Report to the Future Melbourne Committee

Planning Permit Application: TP-2020-235 10-16 Dorcas Street, Southbank

2 February 2021

PLANNING PERMIT APPLICATION DELEGATE REPORT

Figure 11: Separation distance to roof top open space at 22 Dorcas Street
(source: application plans prepared by Plus Architecture)

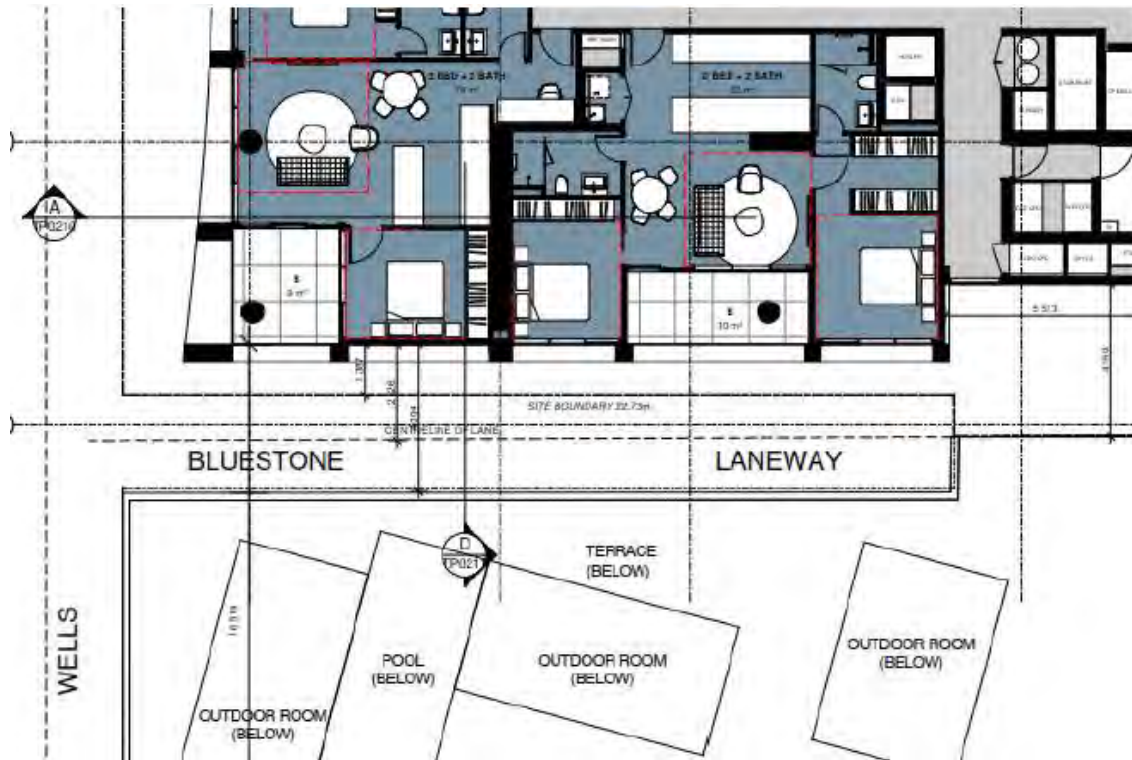
The separation distance to the adjacent roof top communal open space is however far less. This is due to the fact that Levels 14 - 19 would be setback four metres only from the shared boundary and the adjacent open space extends up to the eastern (facing) wall of the adjoining building. To this end, this open space is setback only the width of the bluestone laneway that extends between the two sites.

Figure 11 below shows the separation distance which would exist between the proposed building and the adjacent roof top communal open space.

Notwithstanding the location of this open space, it is considered that the proposed separation distance is sufficient in context. This includes the fact that the open space is communal and as such users do not occupy it as a private space. It is shared and as such its personal amenity value is reduced. Though this does not warrant larger adjacent forms, it certainly allows for some flexibility and this is recognised by the aforementioned amenity-related objectives of Schedule 60. These objectives require the provision of 'adequate' access to sunlight, daylight and outlook only. This is a lesser standard than might otherwise be required in a Neighbourhood or General Residential Zone where a high degree of amenity is rightly expected. In this context, where higher forms are encouraged, reduced amenity often results.

Importantly, outlook from this open space is safeguarded to a degree by the adjacent rear laneway. This, in turn, affords added visual relief in perpetuity and together with the outlook currently enjoyed from adjacent habitable room windows (a minimum distance of 16.5 metres), residents are assured a continued degree of amenity.

Figure 12: Separation distance to facing windows and balconies of 8 Dorcas Street
(source: application plans prepared by Plus Architecture)

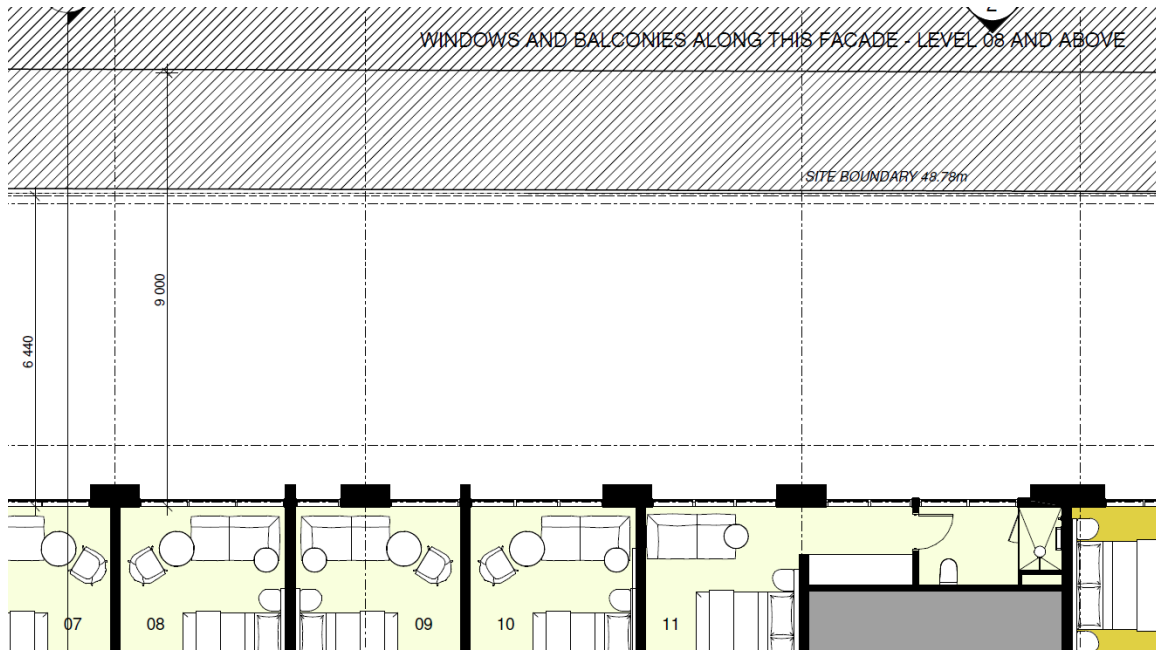
In accordance with the provisions of Schedule 60, Levels 5 - 13 of the proposed building would be setback 6.44 metres from the shared boundary. This, in turn, allows for a minimum nine metre separation distance to facing windows/balconies, as shown in Figure 12 below. This again highlights the role the subject site has played in providing for the amenity of facing windows/balconies. To this end, many existing neighbouring windows/balconies are setback from the shared boundary less than the five metres otherwise preferred by Schedule 60.

Though the nine metre separation distance that would be provided remains less than that preferred by Schedule 60 (10 metres) it reflects that required elsewhere by the planning scheme in the interests of preventing overlooking.

Importantly, the overarching objectives of Schedule 60 include the need to preserve the equitable development potential of adjoining sites. As previously noted, the form of the building is such that it satisfactorily achieves this. To this end, upper level setbacks from the eastern property boundary are greater than that required (6.44 metres in lieu of five metres) and, as a result, setbacks from the western boundary are less than that preferred (four metres in lieu of five). This response reinforces the existing neighbourhood character, including more robust forms built up to or close to property boundaries whilst still providing neighbouring residents with an adequate degree of outlook.

Figure 13: The rear of the approved building at 31 Coventry Street
(source: application plans prepared by Ellenberg Fraser)

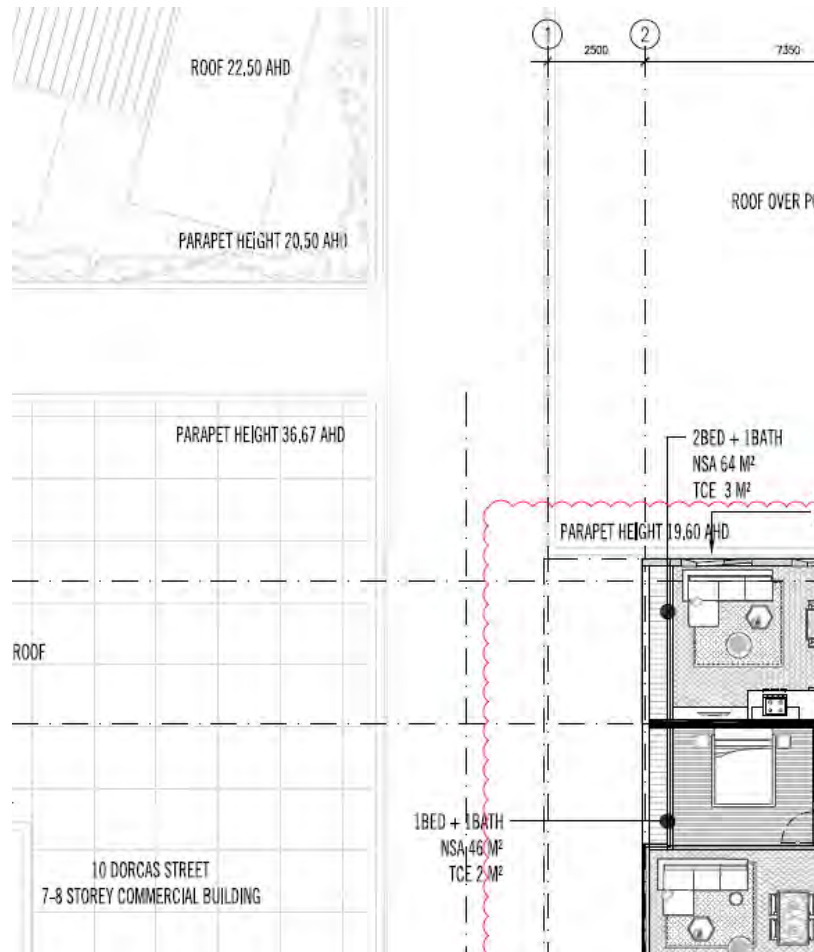
In addition to the relationship of the building to facing sensitive interfaces to the east and west, it is considered that the development is also setback sufficiently from the aforementioned approved development at 31 Coventry Street to the north (refer Figure 5). This approved building will be built to the rear site boundary up to Level 3. Above this to Level 20, the building would then be setback 2.5 metres, or 4.5 metres from the centre of the laneway dividing the two properties. Figure 13 below shows this relationship.

The proposed building would be built up to the laneway to Level 4. Above this, upper floors would be setback five metres from the centre of the laneway as required by Schedule 60. Importantly, this setback is to the glass line only. Integral feature elements of the building would project forward of this and as such reduce the effective setback to the centre of the rear laneway to a minimum of three metres. Importantly, this setback is at one point only. Beyond this, the projecting feature elements would angle backward into the site. Figure 9 shows the form of the rear wing of the building and the feature angled elements in greater detail.

It is considered that the scale of these projecting features might impact upon the general amenity of the residents of facing apartments to the north by way of a perceived (and perhaps actual) loss of outlook. It is considered therefore that the projections should be reduced to no more than 300mm (in accordance with the provisions of Schedule 60). This, in turn, would provide the residents of facing apartments with a greater sense of visual relief and outlook.

1. Prior to the commencement of the use and development hereby approved, the applicant shall submit to and have approved in writing by the Responsible Authority, electronic plans generally in accordance with those submitted with the application prepared by Plus Architecture and dated 6 March 2020 but amended to show:
 - a) The overall height of the building reduced to a maximum of 70 metres, as measured to the Australian Height Datum (AHD). This excludes all non-habitable architectural features less than 3.0 metres in height and building services;
 - b) The depth of the projecting rear elements at Levels 5 - 13 reduced to no more than 300mm beyond the adjacent glass line. The corresponding projections at Levels 14 - 19 may also be reduced to match;
